**DEVIATION REQUEST
AND DECISION FORM**

Project Name : **BENT GRASS EAST COMMERCIAL FILING NO. 3**
 Schedule No.(s) : 53011-01-060
 Legal Description : Tract BB, Bent Grass East Commercial Filing No. 2B

A deviation from the standards of or in Section **2.2.4.B.6 and 2.5.2.B.3** of the Engineering Criteria Manual (ECM) is requested.

TYPICAL PRIVATE ROAD CROSS SECTION

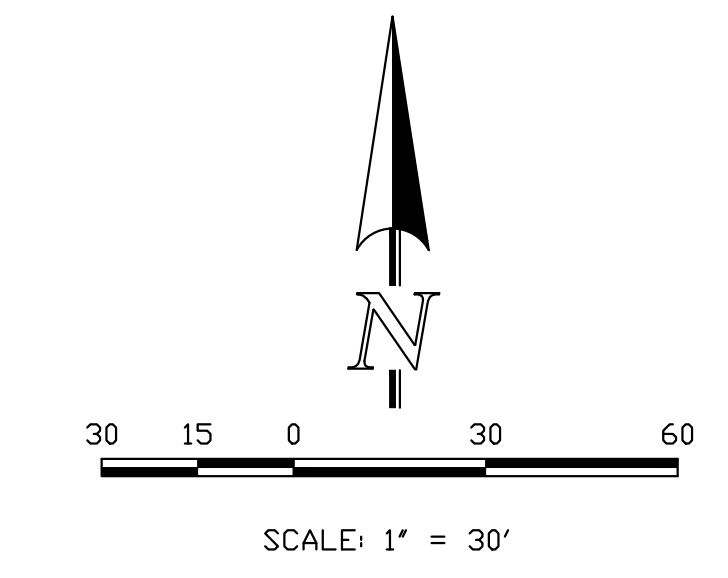
Private roadway Tract width proposed is 40' compared to std. 50' Right-of-Way with esmts. Additional esmts. provided for utilities and sidewalks.

Paved width proposed is 30'. This width is consistent with the County std. urban local roadway.

Sidewalk (5.0' attached) is proposed along one side of the private roadway only with two mid-block pedestrian ramp crossings compared to both sides for Local.

This request has been determined to have met the criteria for approval. A deviation from Section 2.2.4.B.6
2.5.2.B.3 of the ECM is hereby granted based on the justification provided.

BENT GRASS EAST COMMERCIAL FILING NO. 3			
PEDESTRIAN ACCESS EXHIBIT			
DESIGNED BY	MAW	SCALE	DATE 8/30/21
DRAWN BY	MAW	(H) 1" = 30'	SHEET 1 OF 1
CHECKED BY		(V) 1" = N/A	JOB NO. 2177.64

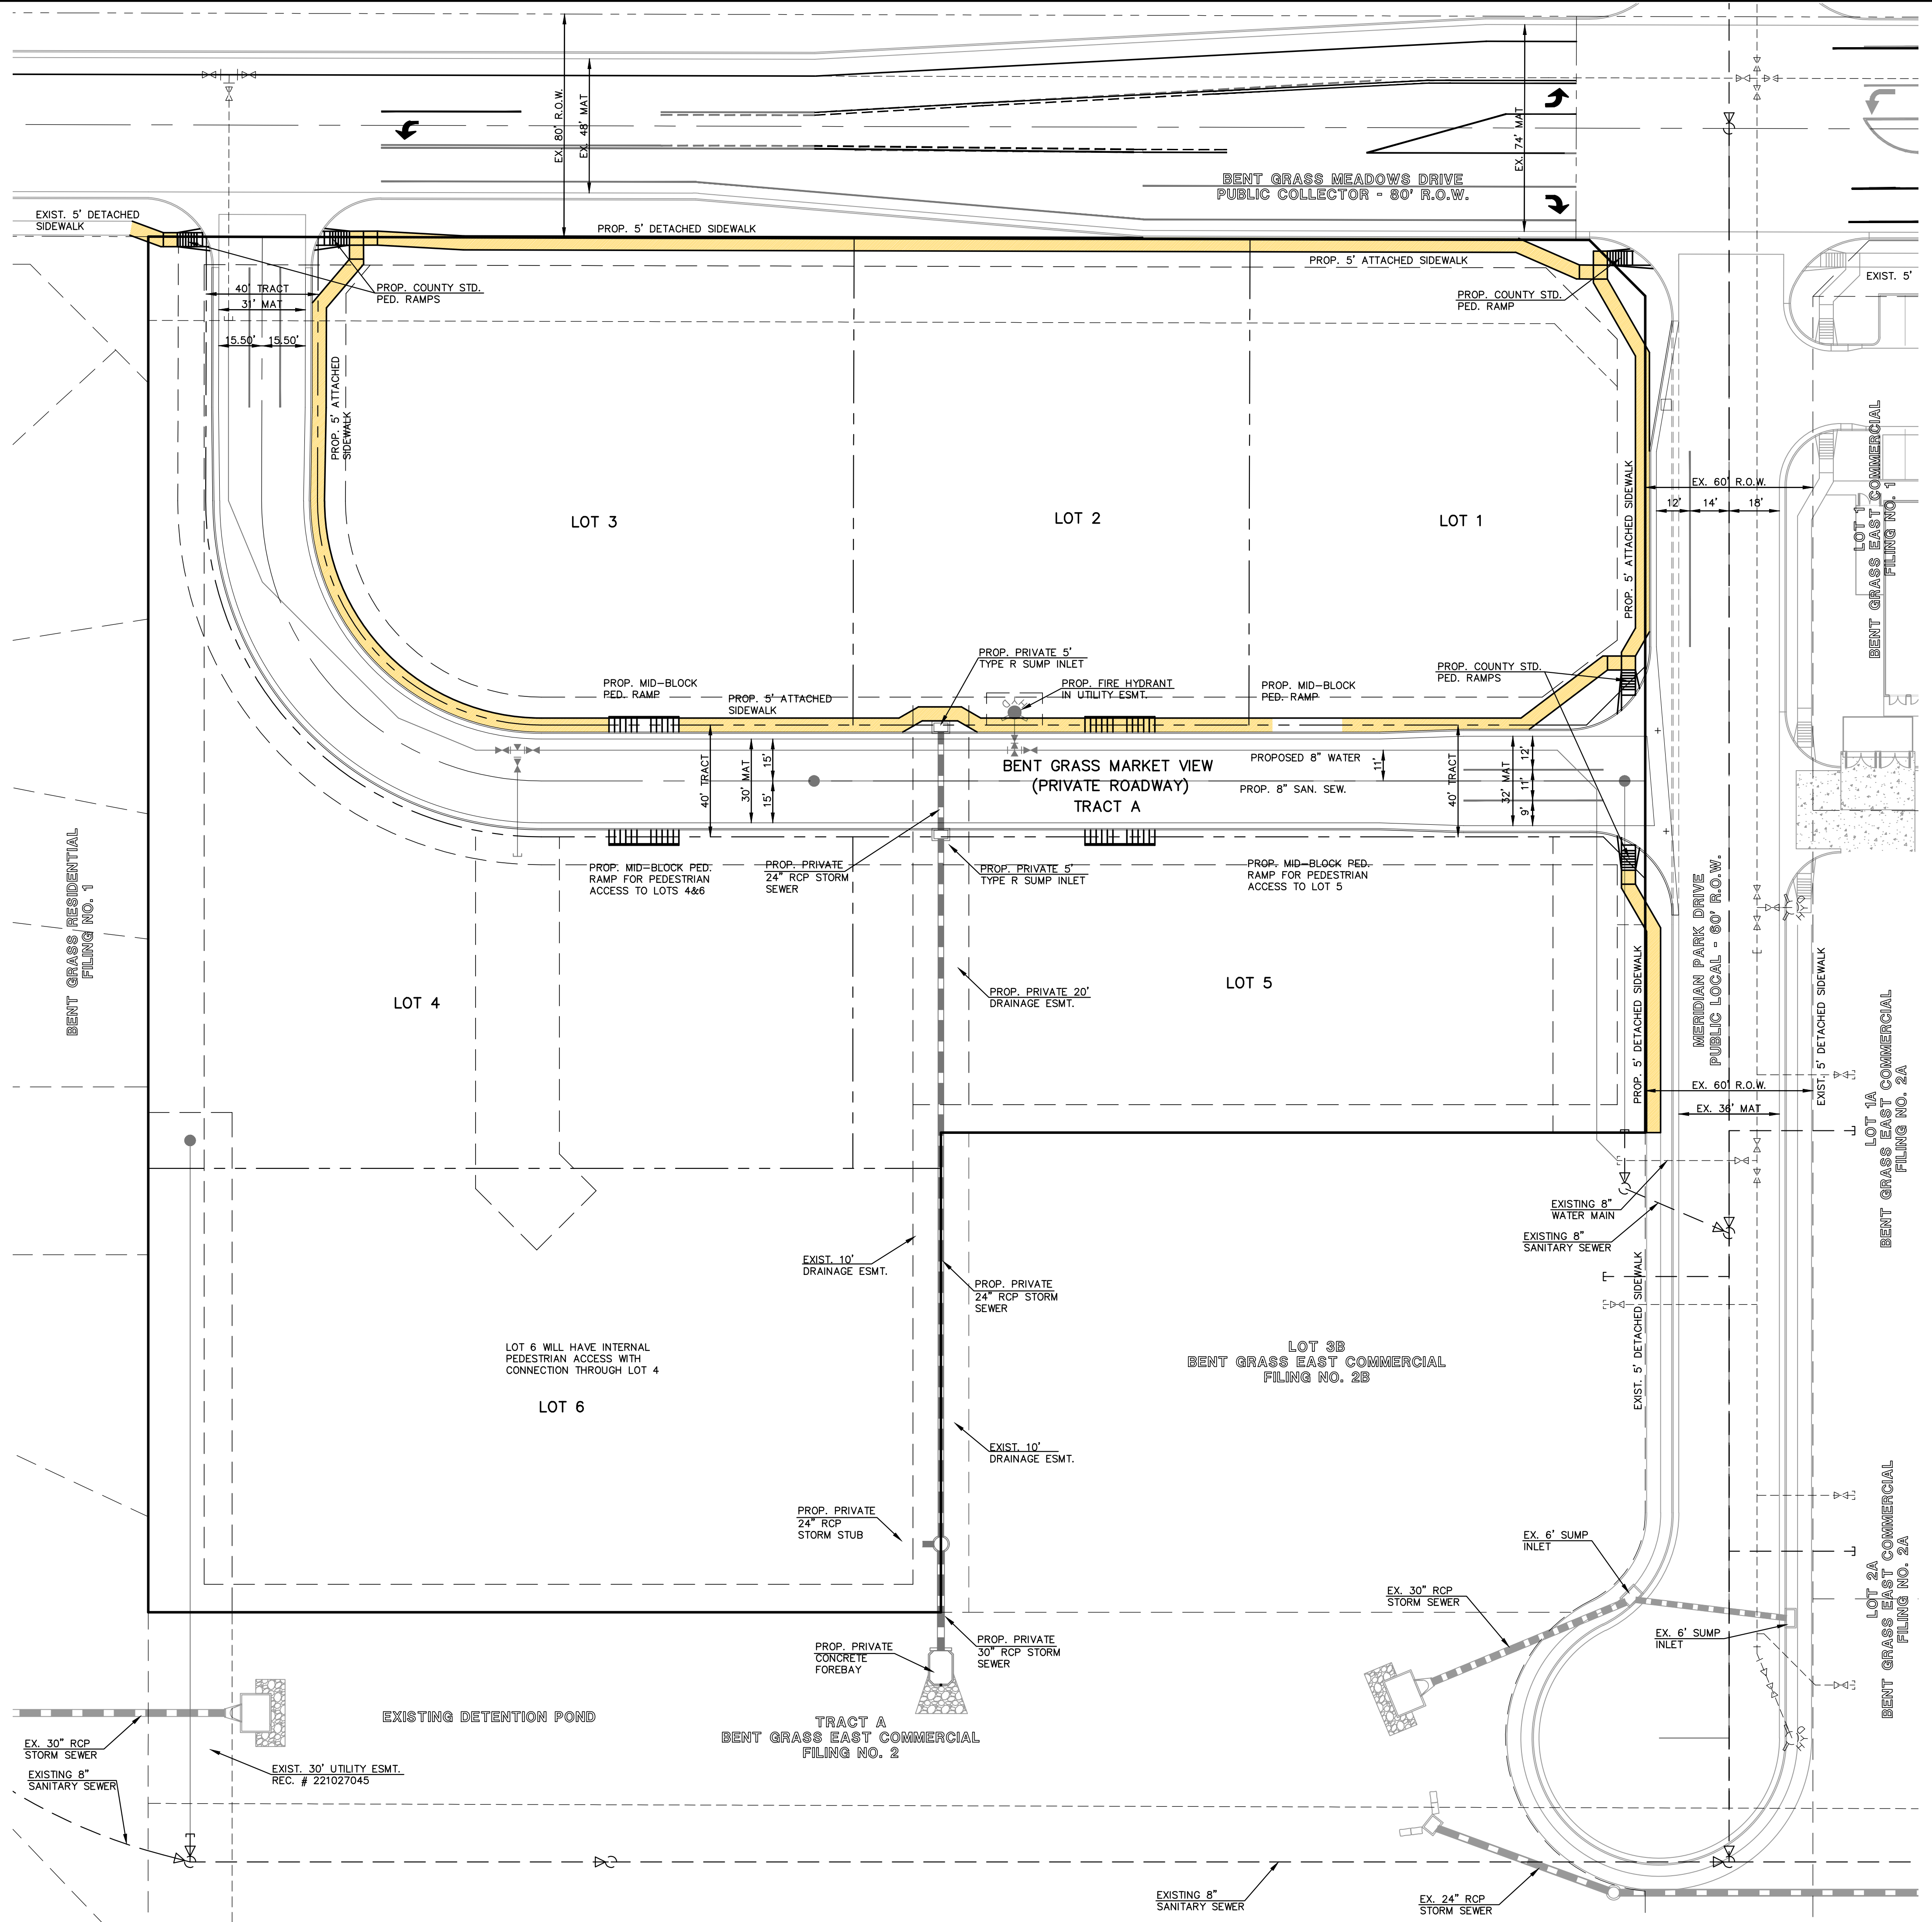
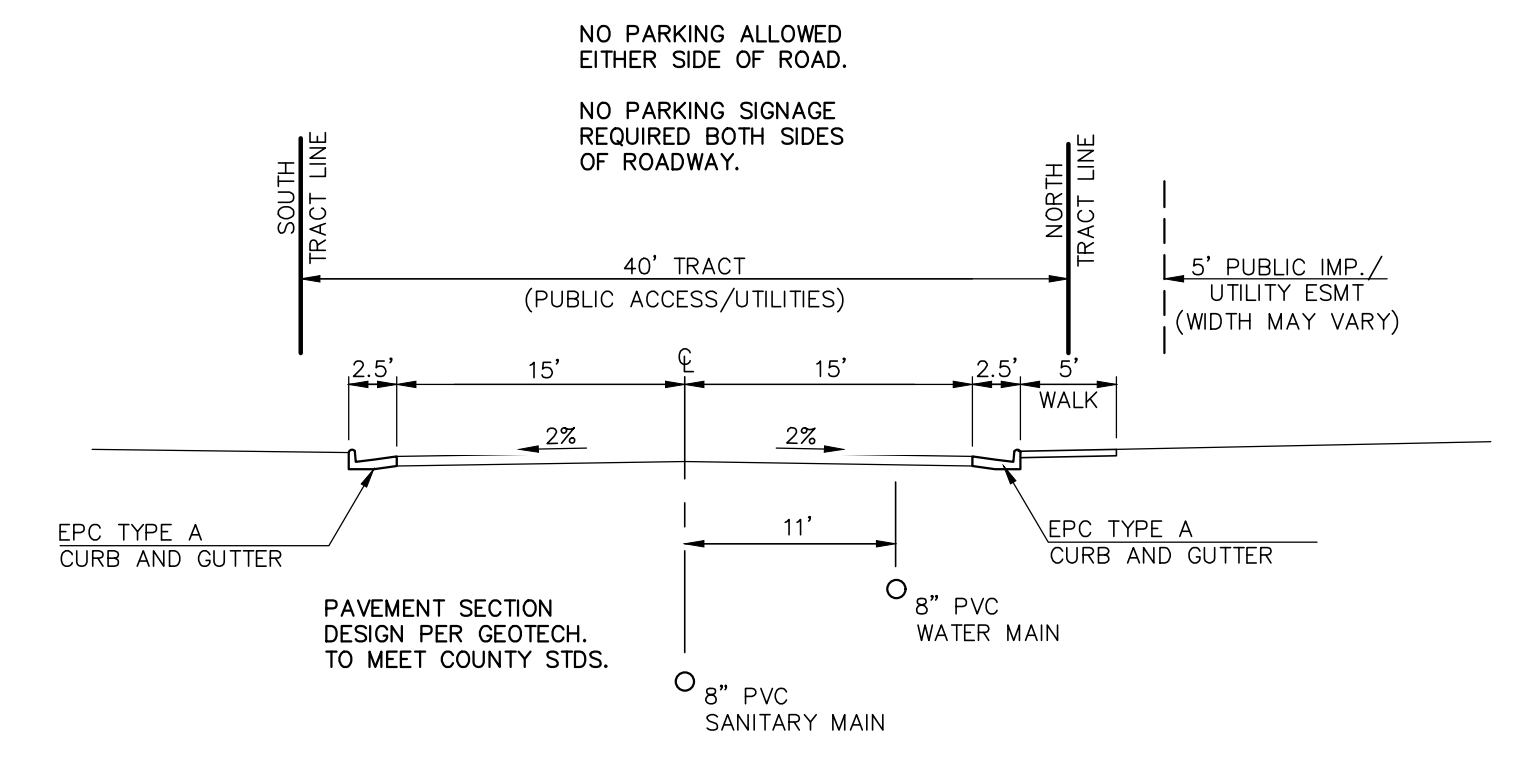
The ECM does not provide an option for a private roadway for a commercial development such as this. A public Right-of-Way meeting all the County stds. limits the development ability for a commercial project like this. A private roadway with similar yet modified design aspects from the ECM std. will allow for adequate access without compromising public safety or accessibility. Per the TIS, the proposed private roadway design seems to be adequate to handle the site generated traffic. Per the provided truck turning exhibit for B-40 bus, the proposed CL radius provides adequate truck access through the site. Pedestrian access is provided to each lot with the proposed 5' attached sidewalk on one side of the road along with two mid-block pedestrian ramp crossings. Sidewalk is also provided on the perimeter of the site adjacent to Bent Grass Meadows Drive and Meridian Park Dr. which allows for further pedestrian circulation.

TRUCK TURNING EXHIBIT
(B-40 BUS)

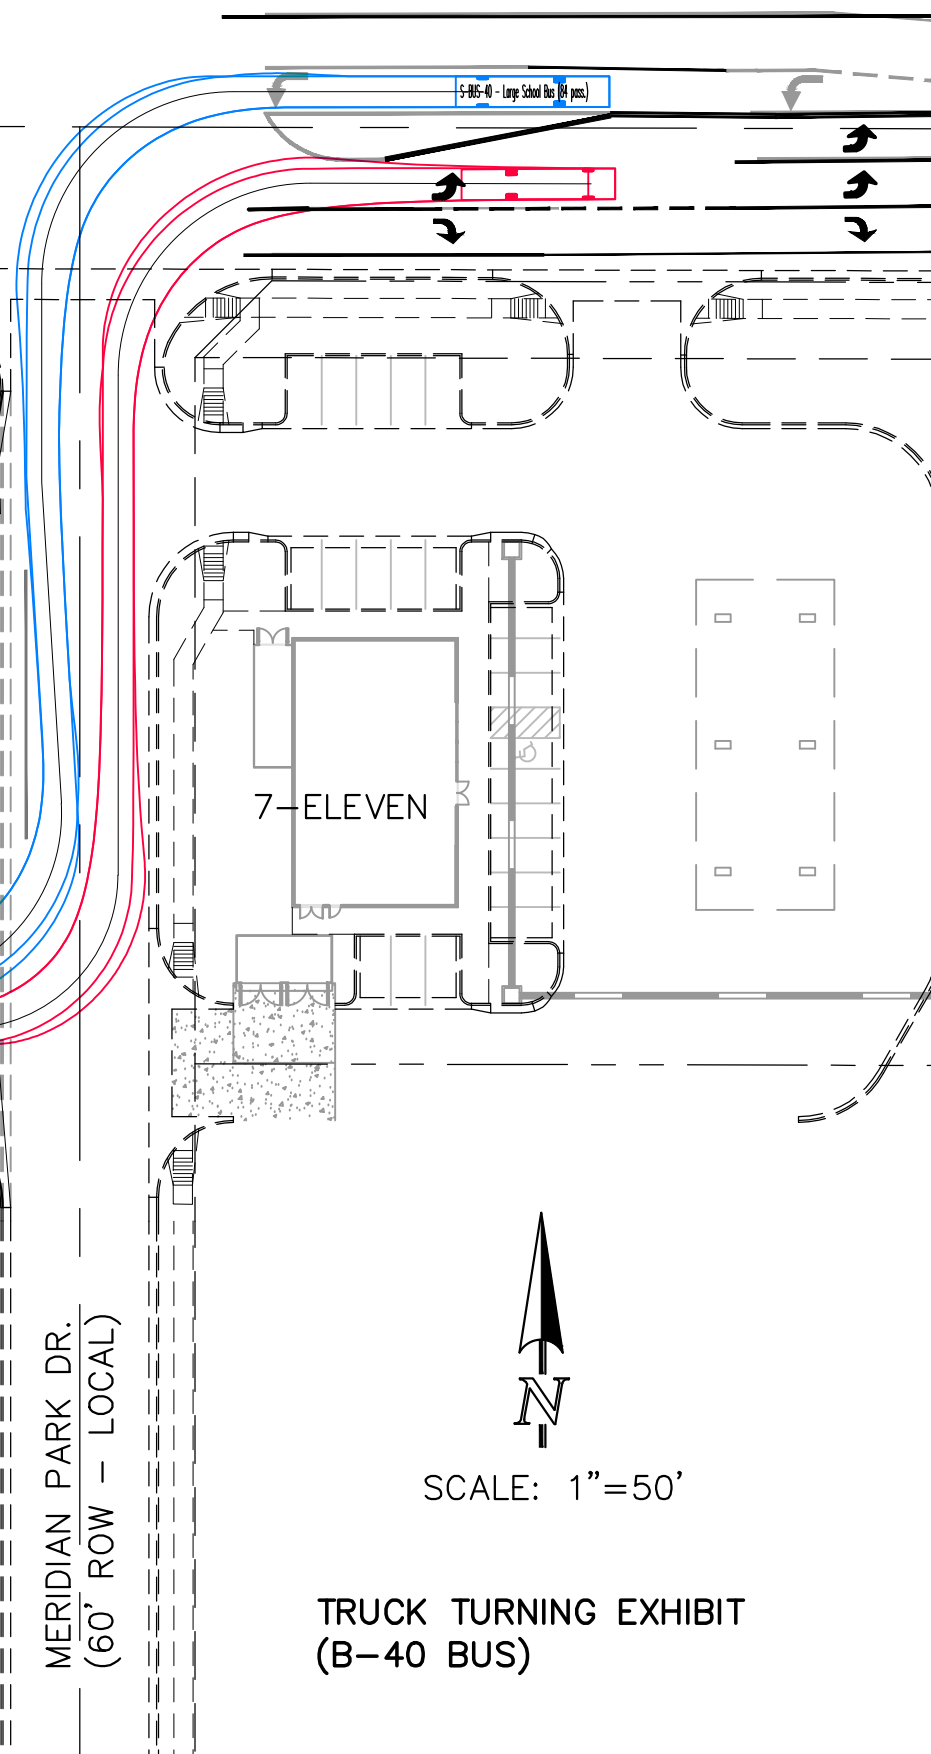
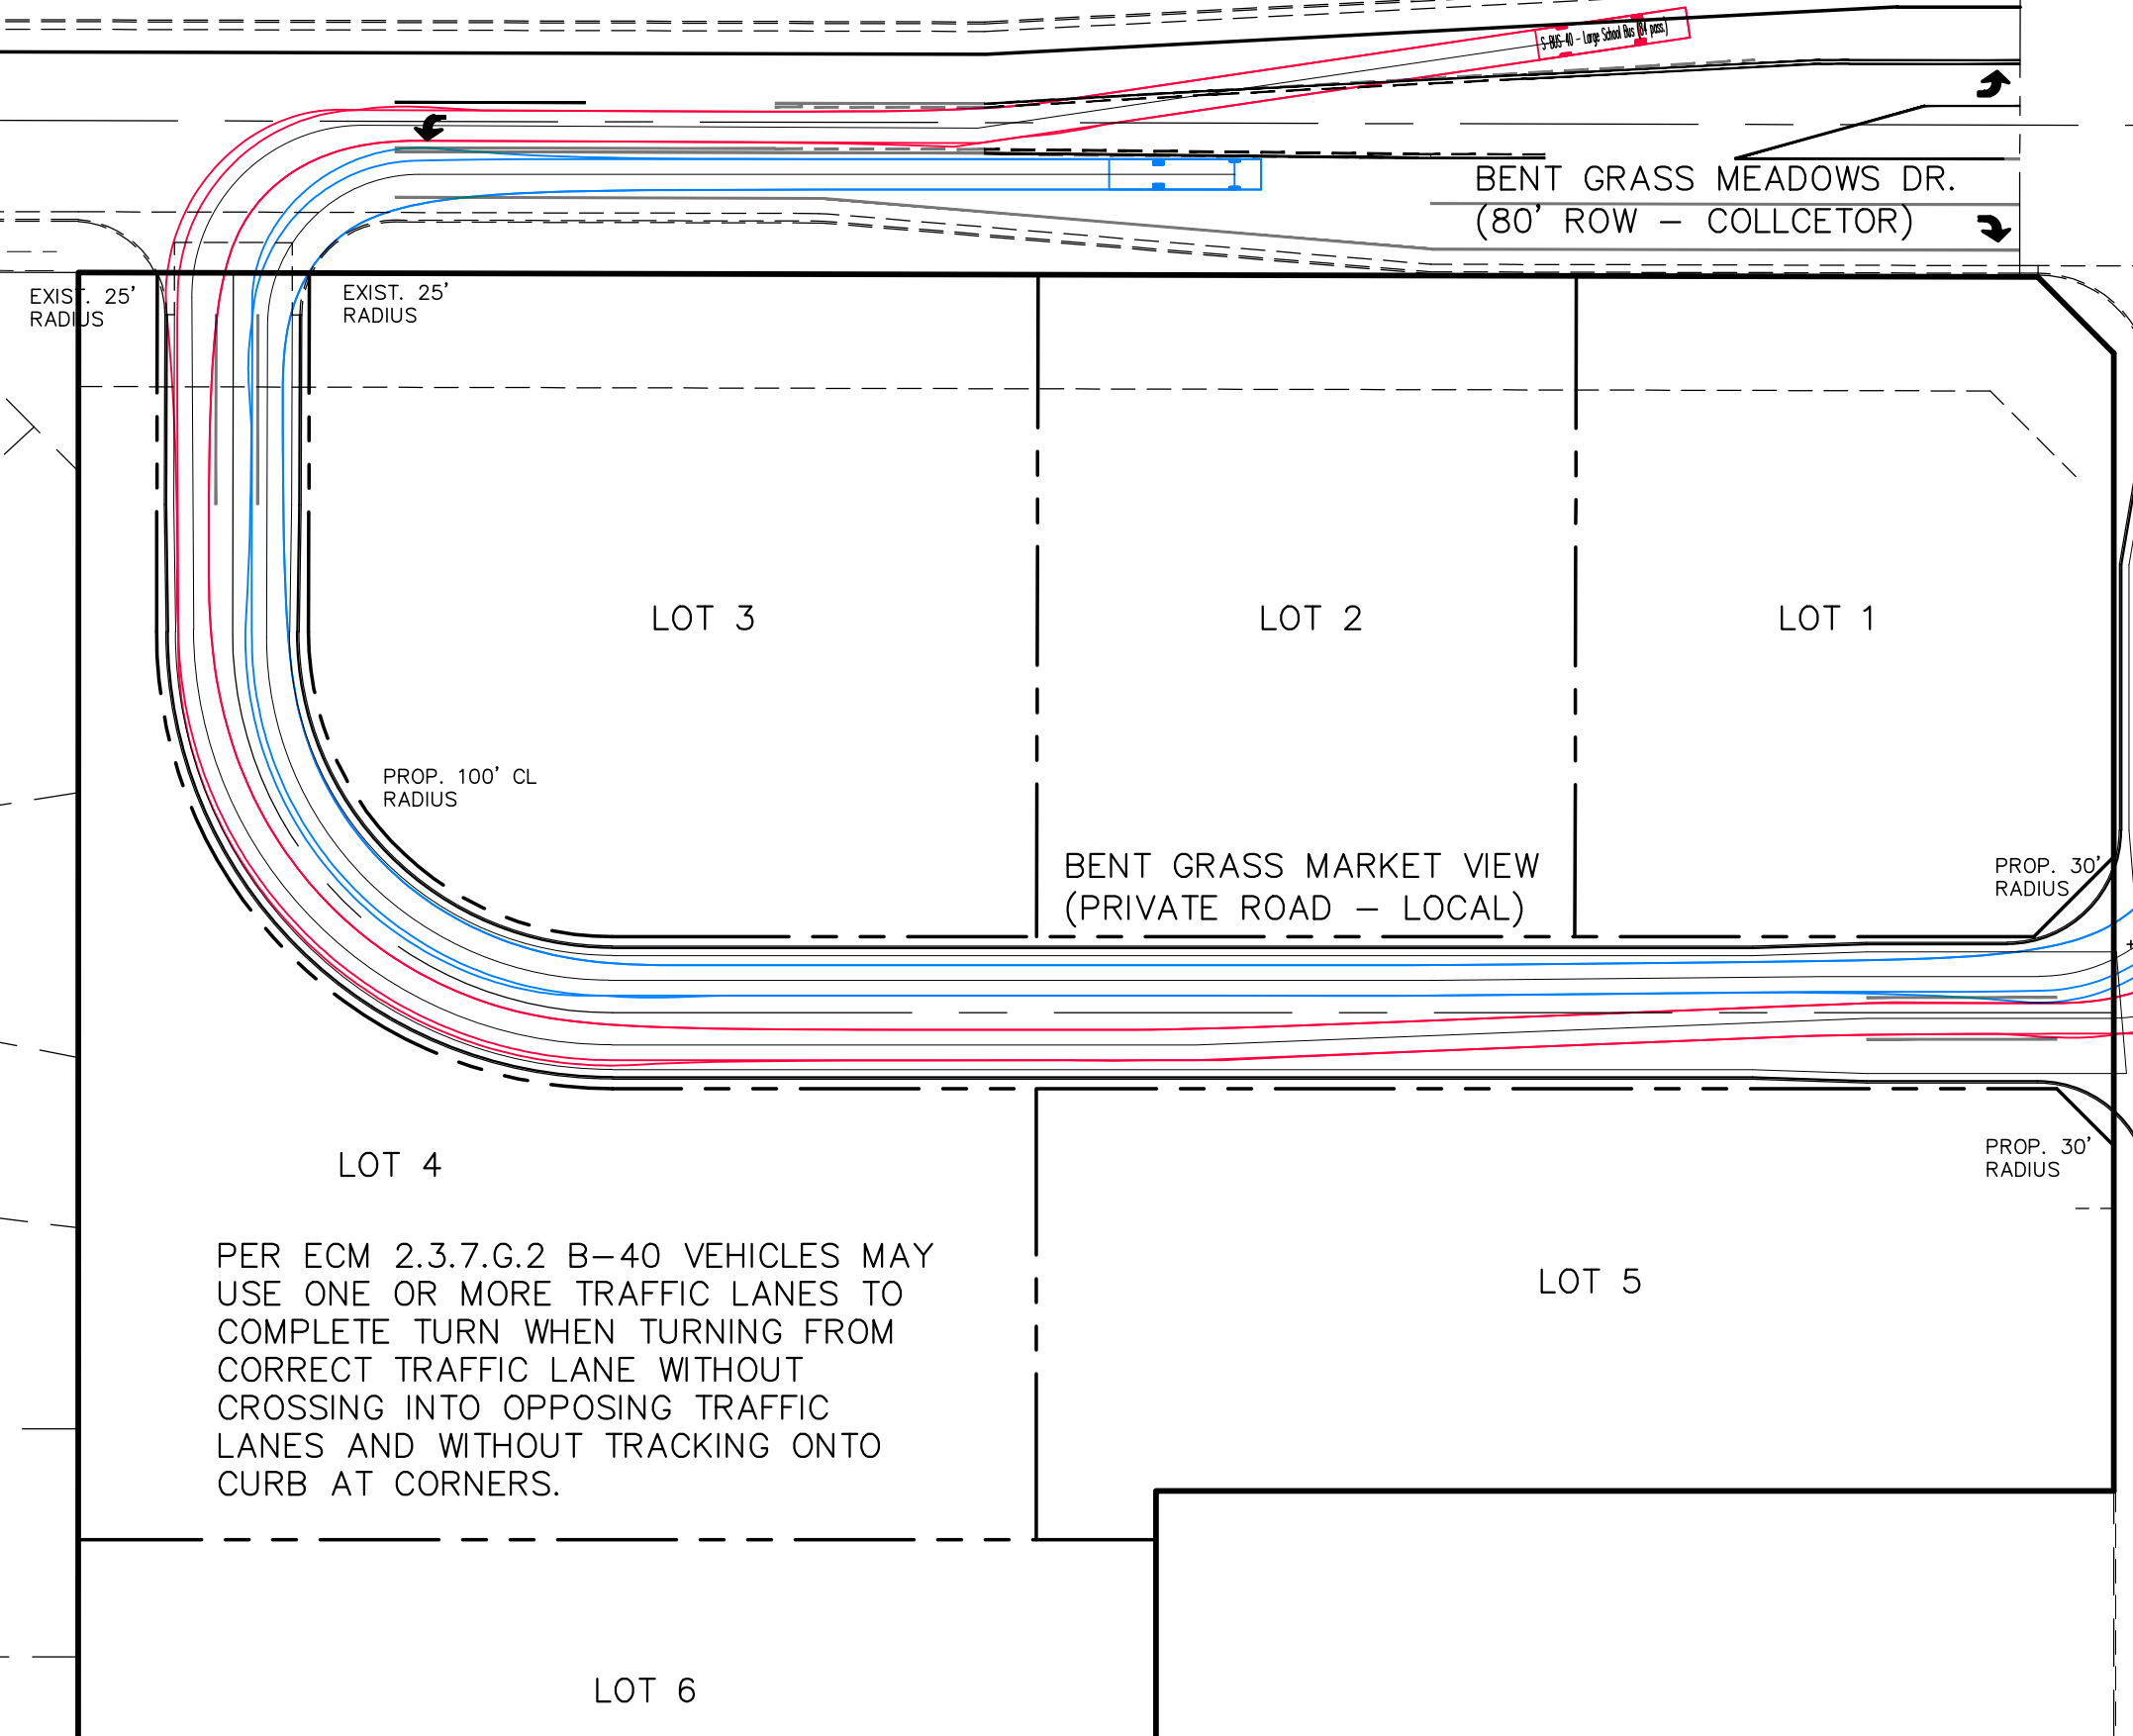
Min. CL curve Radius proposed is 100' compared to the 200' for Local and 100' for Local low-volume. (Reference attached truck turning exhibit showing adequate site access)

PER ECM 2.3.7.G.2 B-40 VEHICLES MAY USE ONE OR MORE TRAFFIC LANES TO COMPLETE TURN WHEN TURNING FROM CORRECT TRAFFIC LANE WITHOUT CROSSING INTO OPPOSING TRAFFIC LANES AND WITHOUT TRACKING ONTO CURB AT CORNERS.
